STATE OF CONNECTICUT
CONNECTICUT SITING COUNCIL

DOCKET NO. 440

RESPONSES OF NEW CINGULAR WIRELESS TO CONNECTICUT SITING COUNCIL
PRE-HEARING QUESTIONS SET I

Existing and Proposed
 @ 97 feet AGL Coverage

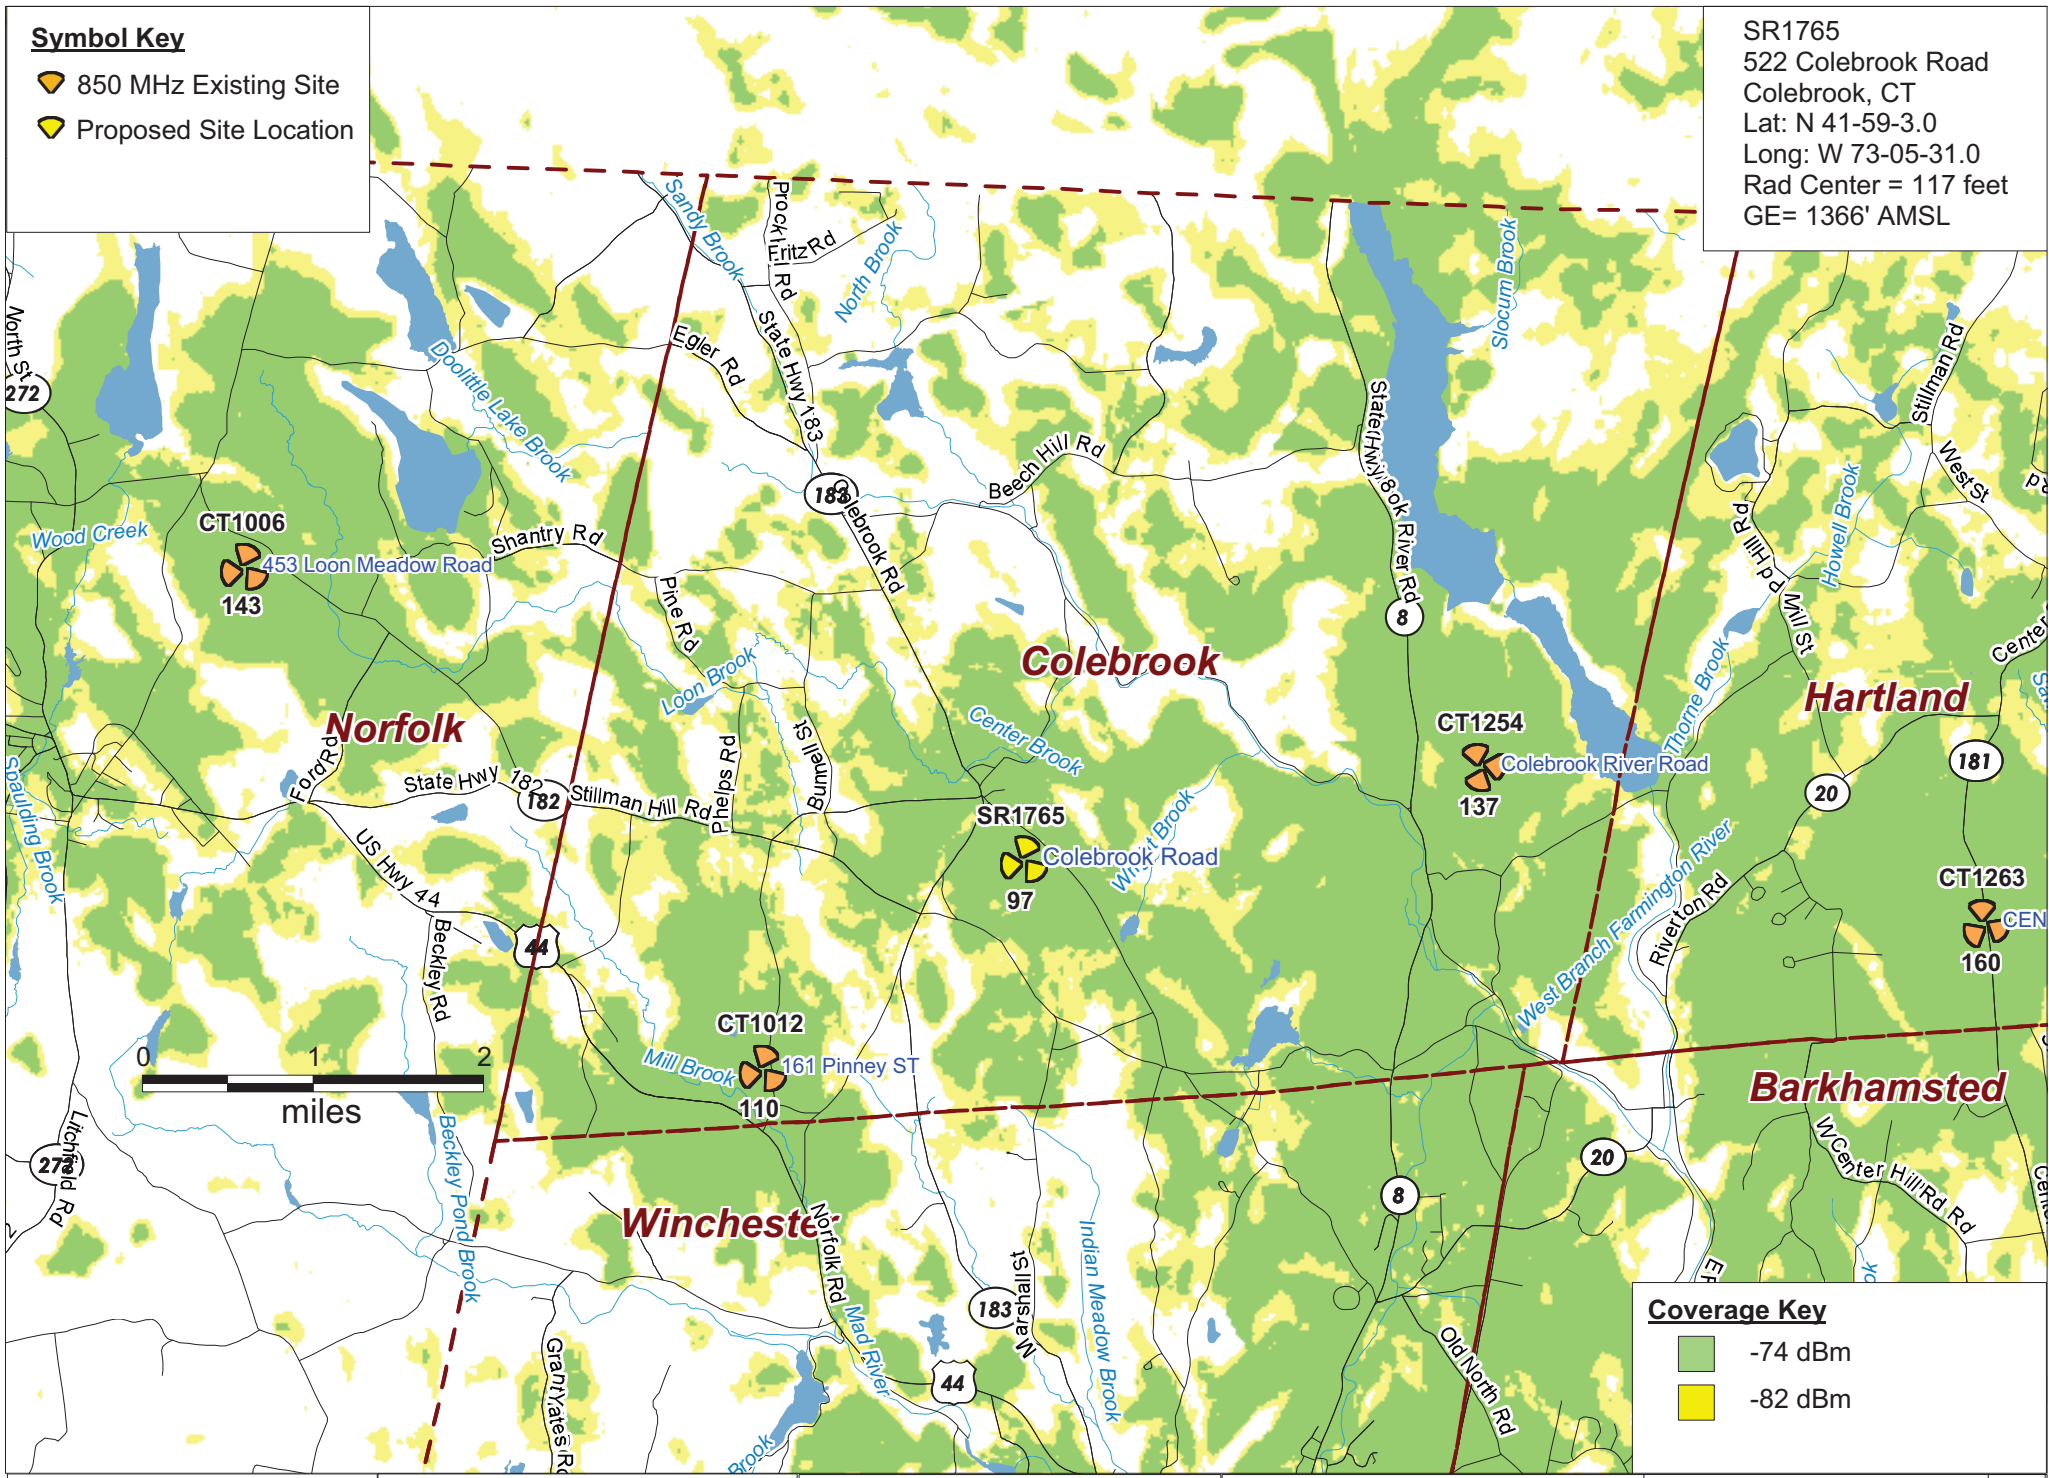
Q16. Using the same scale as the coverage plots in the Radio Frequency Analysis Report, provide separate coverage plots assuming the tower is ten and twenty feet shorter.

A16. Included in Attachment 3 are propagation maps depicting existing coverage and proposed coverage at antenna centerline heights of 107' AGL and 97' AGL (ten and twenty feet lower than the proposed antenna centerline height of 117' AGL). These propagation maps show gaps to the north and west, particularly along Routes 183 and 182.

Wetlands Delineation Map

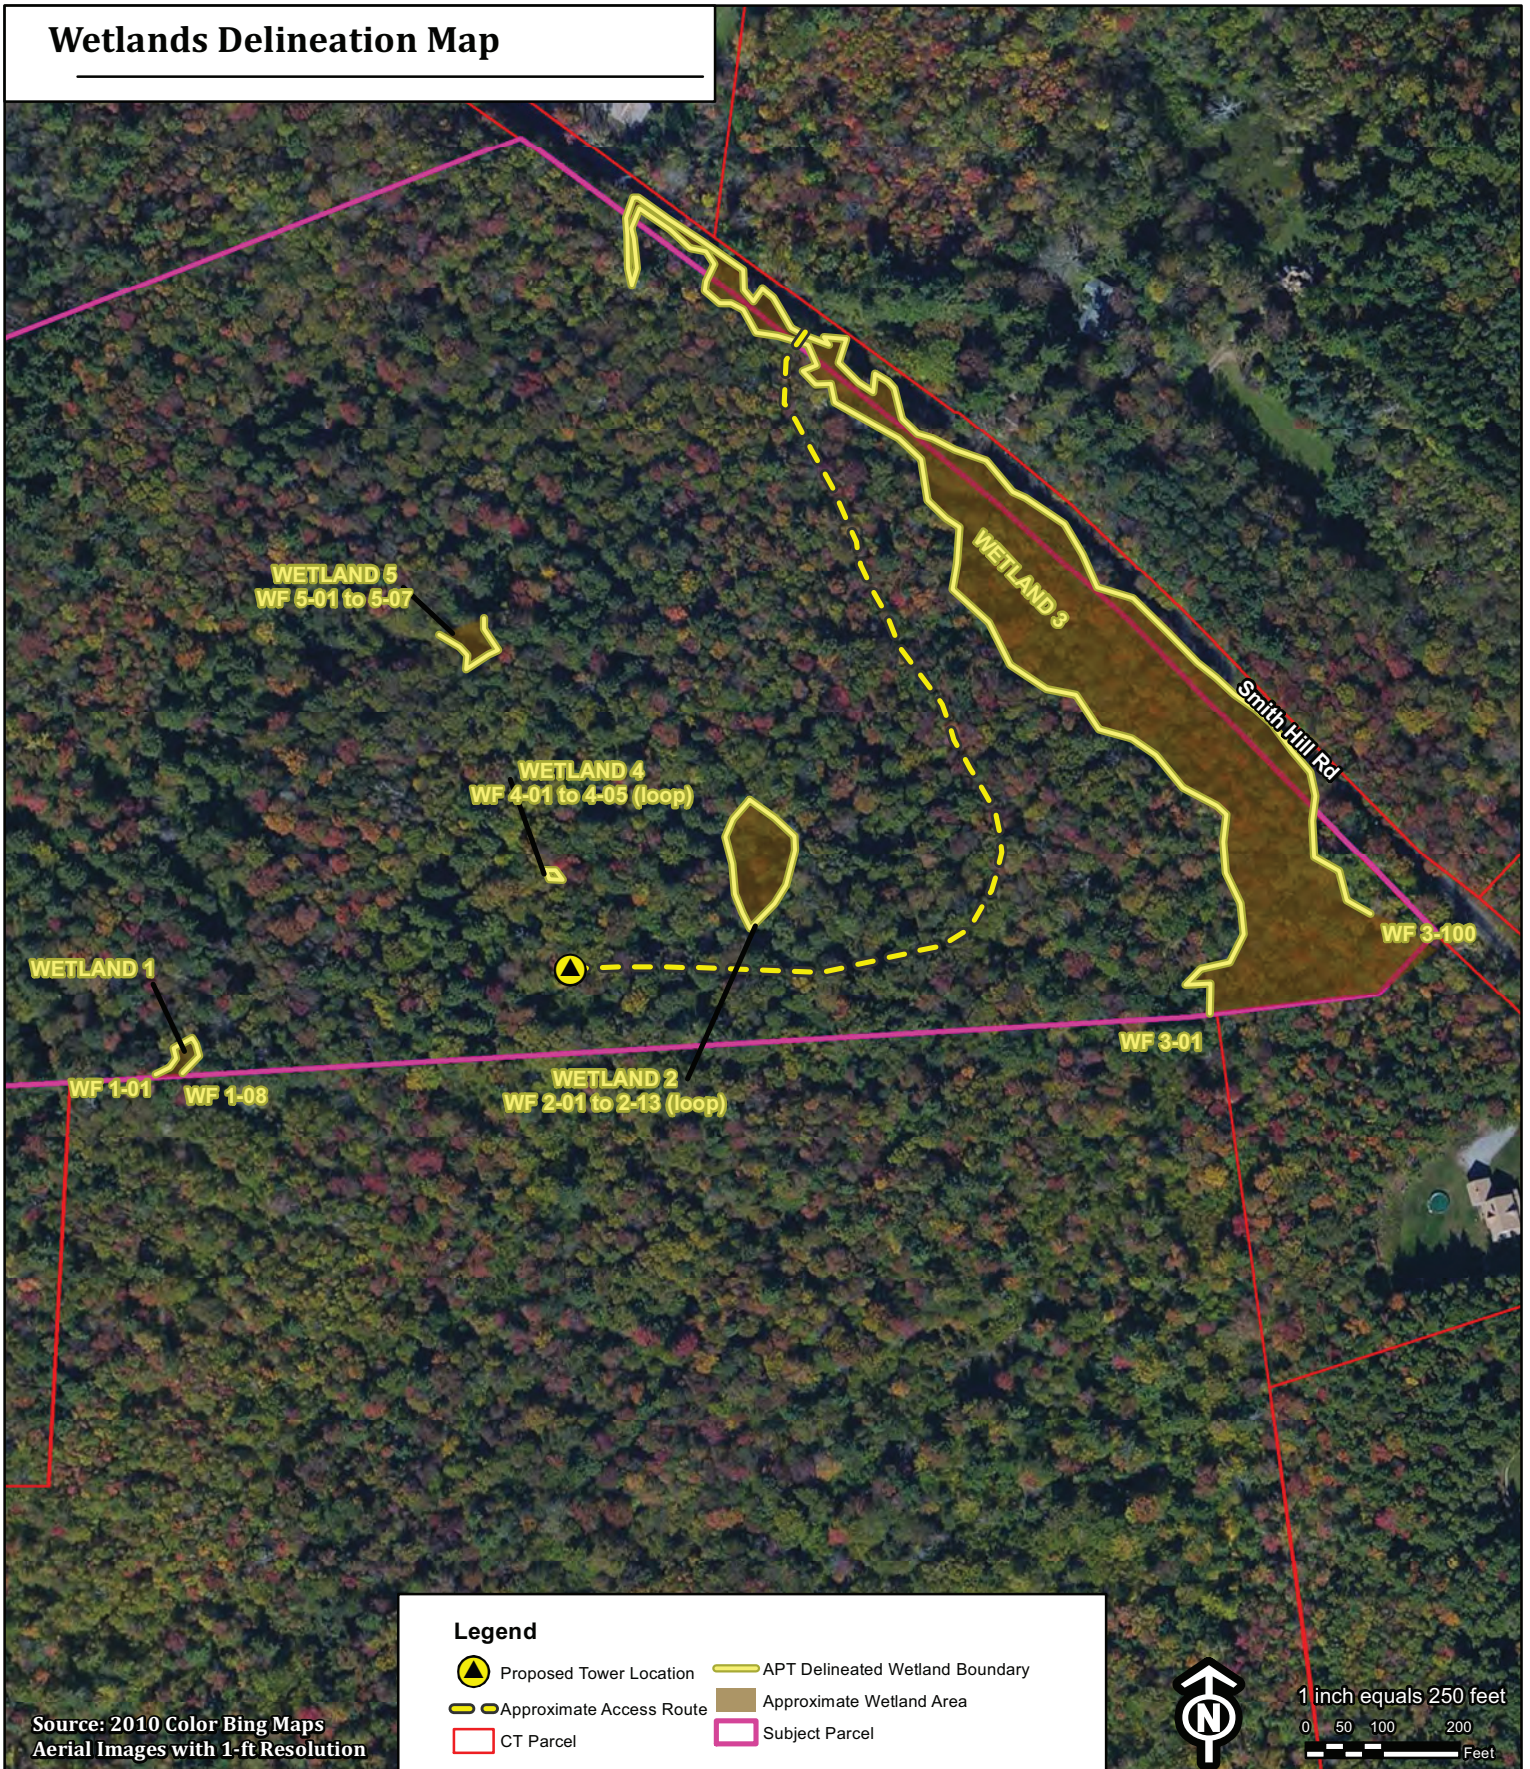
Q37. Provide a map or drawing depicting the wetland locations on the subject property.

A37. The drawings included in Tab 3 of the Application include the wetlands delineation. In addition, a copy of the June 14, 2013 Wetland Investigation Report with a Wetlands Delineation Map is provided in Attachment 5.
